DELEGATE REPORT

MINISTERIAL PLANNING REFERRAL

CoM Application Number:	TPM-2022-23
DTP Application Number:	99000673
Applicant:	MAB Corporation Pty Ltd c/- Contour
Owner:	Development Victoria
Architect:	ARM Architecture
Address:	396-416 Docklands Drive, Docklands
Proposal:	Proposed Amendment (Addendum) to the MAB Docklands Development Plan (1999)
Cost of Works:	N/A
Date Application Received:	27 October 2022
Date s.50 Application Received:	31 August 2023
Responsible Officer:	Richard Cherry, Principal Urban Planner

Figure 30: Demonstration of buildings above the DDO54 preferred maximum building heights

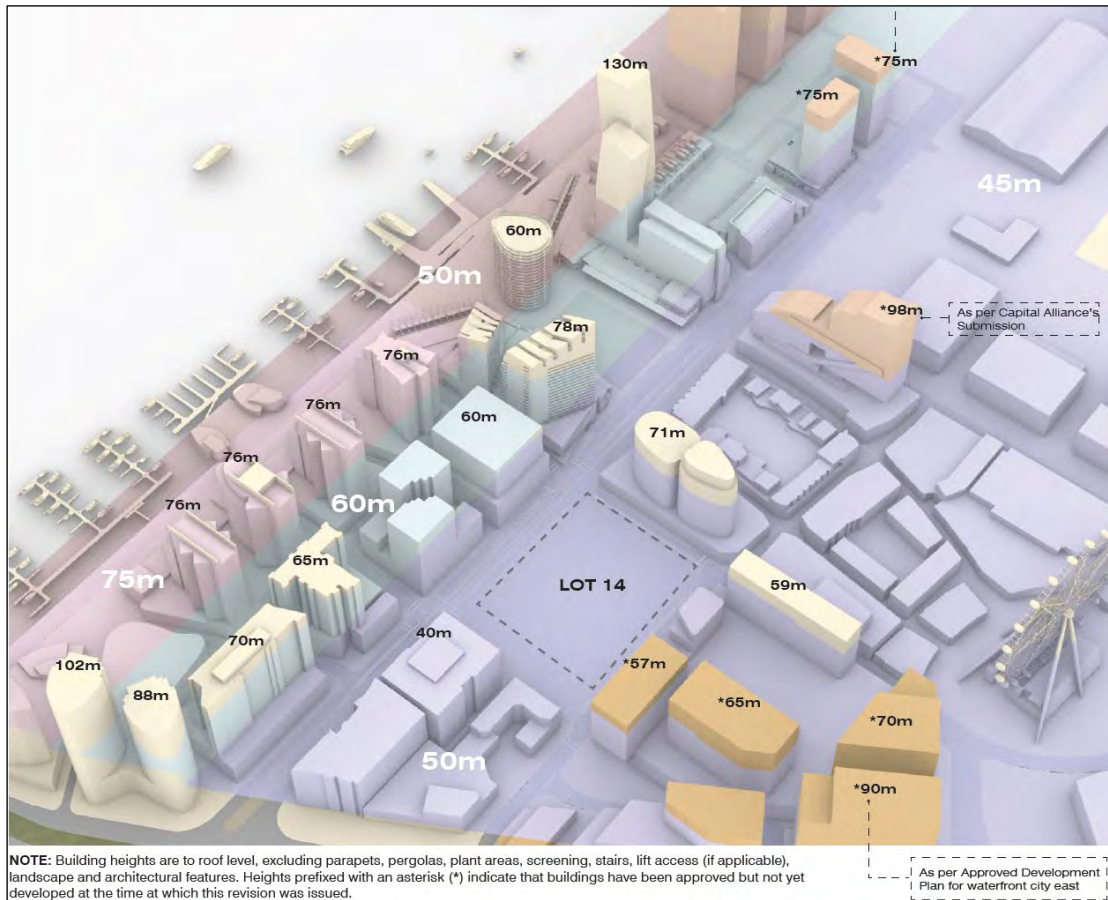
<p>from what was envisaged by the height controls originally. Refer Figure 30, prepared by ARM Architecture, demonstrating the approved / constructed buildings that protrude above their respective DDO54 preferred maximum building height control.</p> <p>The proposed building heights on the subject site have sufficient variation amongst them – being 25 m in height difference between the lowest and highest, creating a dynamic skyline profile.</p> <p>The heights will readily assimilate with the heights approved or constructed nearby, including the Marriott to the west (approximately 68 m), the AsheMorgan site to the north (ranging between 12 m and 90 m), and the varying heights of New Quay to the south.</p> <p>It is also noted that Buildings 2 and 5 within the site directly to the north, which is part of the Waterfront City East Development Plan, are currently proposed at heights of 78 m and 63 m respectively. This application is currently under consideration (TPM-2023-13).</p>

On balance, and considering the general increase in height of buildings approved nearby in Docklands above DDO54 controls, as shown in Figure 30, an increase in height from the current DP is a built form outcome that can be achieved in this context. However, this is on the basis that appropriate street wall, setbacks and separation is also achieved.

Figures 31: Proposed DP Section 4.6 (Podium Design, Towers Forms and Setbacks) – **Example #1**

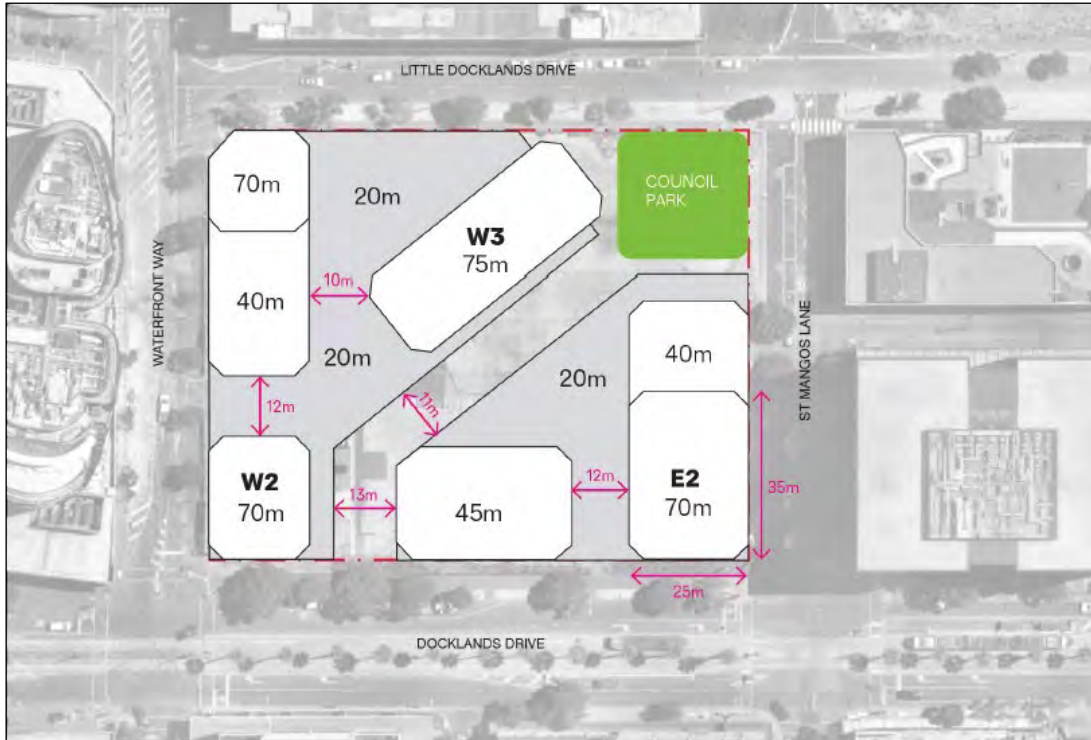
While Example #2 is preferred, Example #1 would still be considered an acceptable alternative as the 70 m street walls are confined to the north-west and south-west corners only. Notwithstanding, it is recommended that the 70 m street walls to these corners are dimensioned to a maximum 25 m, which could form a CoM recommended change to DTP – **refer recommendation at Section 9.1 of this report.**

- Update Tower Forms and Setbacks sub-heading > dot point 1:
 - Maximum tower heights as depicted in the preferred Maximum Building Height plan (Refer 4.2 **4.7** Urban Design - Maximum Building Heights).

Figures 32: Proposed DP Section 4.6 (Podium Design, Towers Forms and Setbacks) – **Example #2**

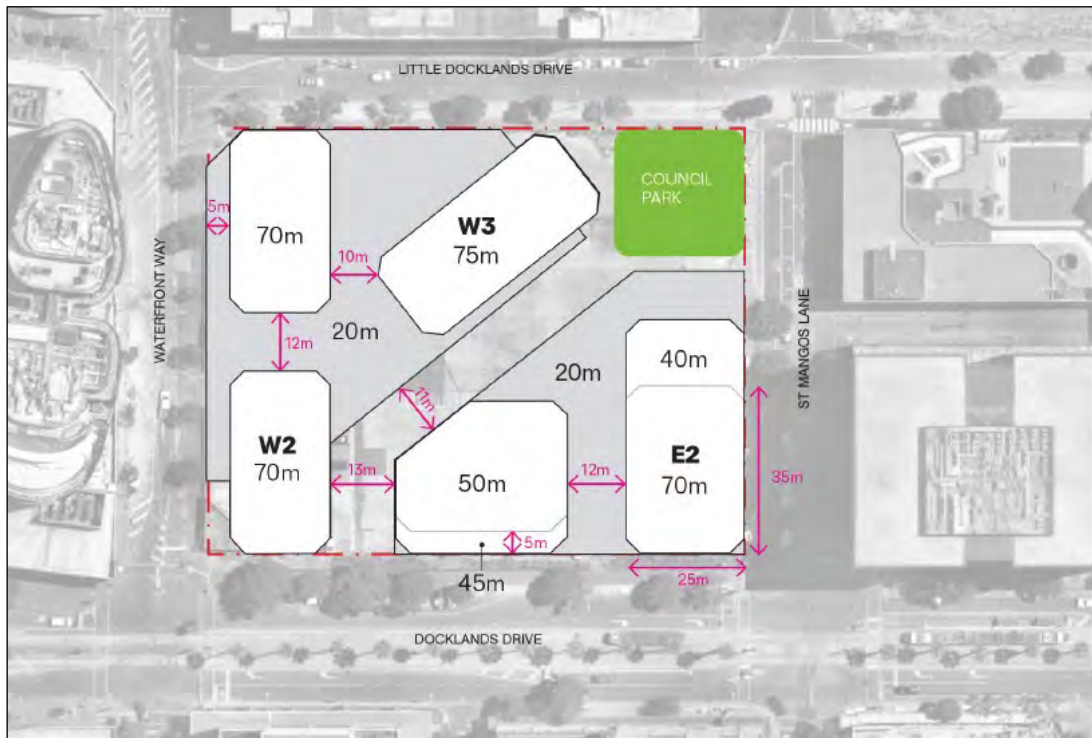
Example # 2 is preferred as it provides minimum 5 m setbacks to the two 70 m towers on the north-west and south-west corners; and a 5 m setback to the central building above 45 m to Docklands Drive. These setbacks generally respond to the context informed parameters listed above and are introduced alongside the following design principles:

- *Towers ~~should~~ **must** maintain a **minimum** 5 m setback above Street Wall except where Corner Towers are permitted.*
8. New subsection to Section 4.0 (Concept Plan) of the proposed DP addendum headed "Urban Art" and include the following paragraph:

Figure 33: Proposed DP Section 4.8 (Building Separation, Light and Views)

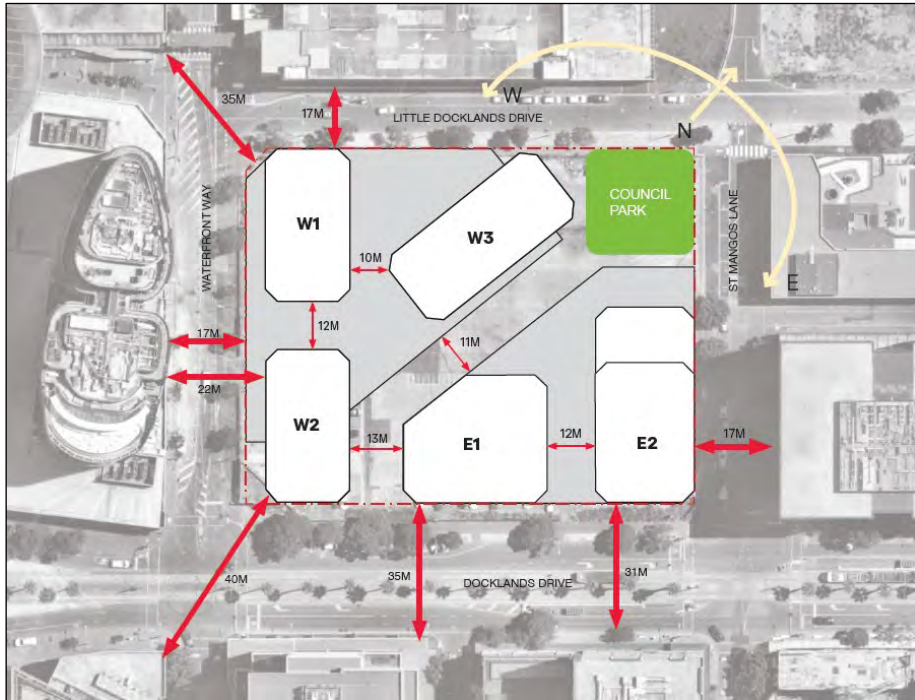
All towers are proposed to be separated by a minimum of 10 m and an average of 12 m. The tower separation has responded to the relevant DDO54 decision guideline to provide spacing of building bulk and to avoid the creation of a wall effect. This also assists to ensure views between buildings and to achieve privacy, daylight and outlook amenity.

The central laneway proposes an 11 m width, widening to 13 m at the southern end with provision for 1 m projections.

Figure 39: Proposed DP Section 5.3 (Pedestrian Access Plan)

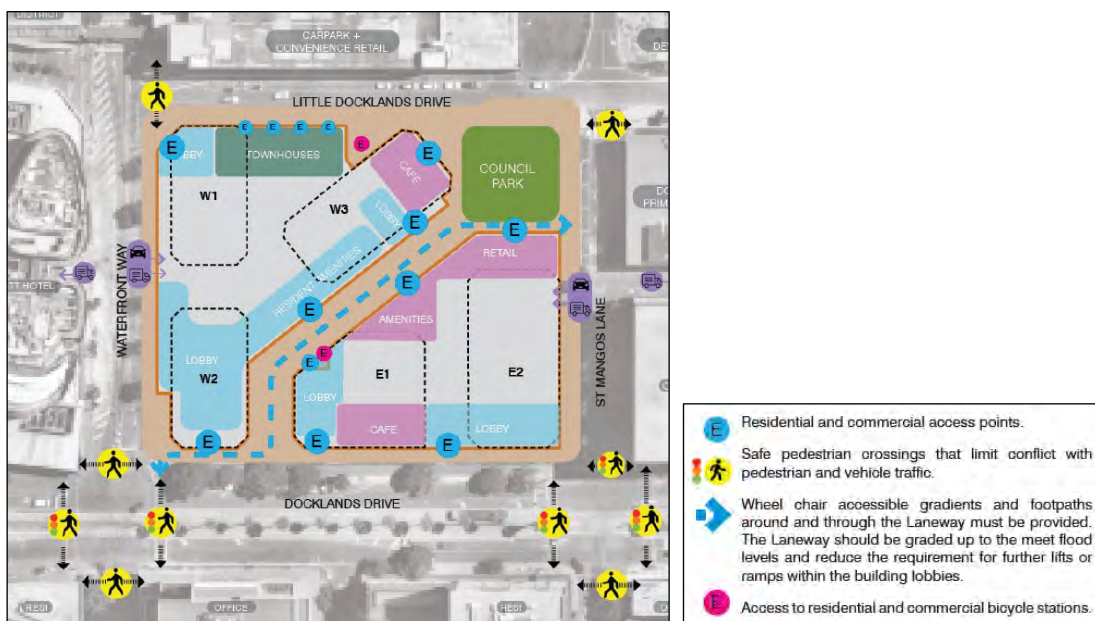
As illustrated in Figure 39, the proposed DP addendum now allows for pedestrian movement through the site at ground level and several residential and commercial access points around the site, but importantly away from the dedicated vehicle points. Further, wheelchair access would be provided along the laneway.

The revised pedestrian connections are therefore considered to be acceptable.

Figure 40: Proposed DP Section 5.1 (Vehicle Access)

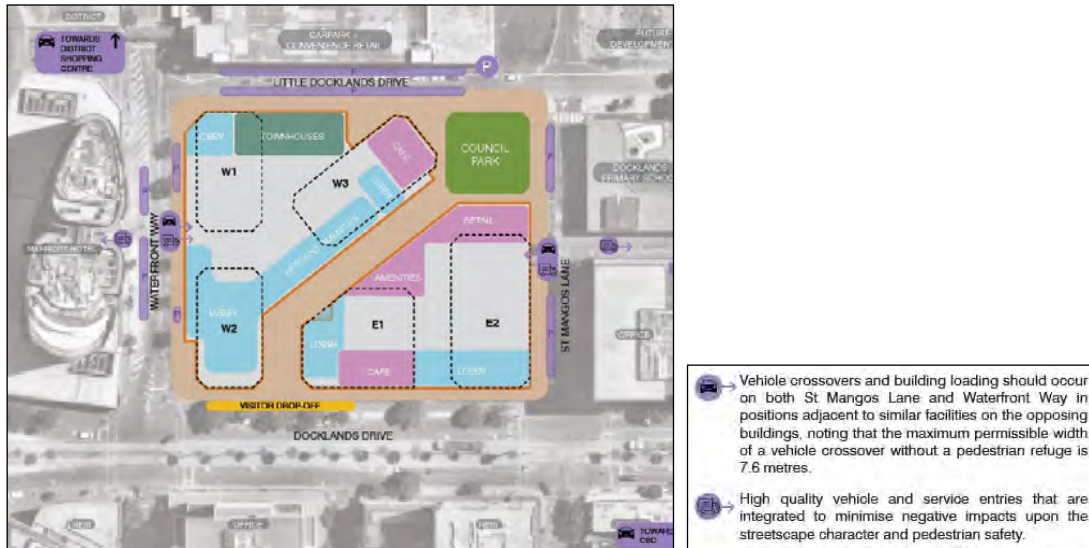
As illustrated in Figure 40, the proposed DP addendum would retain vehicle access to these minor streets and importantly, away from the main residential and commercial pedestrian entry points. Further, CoM Traffic Engineering supports these locations.
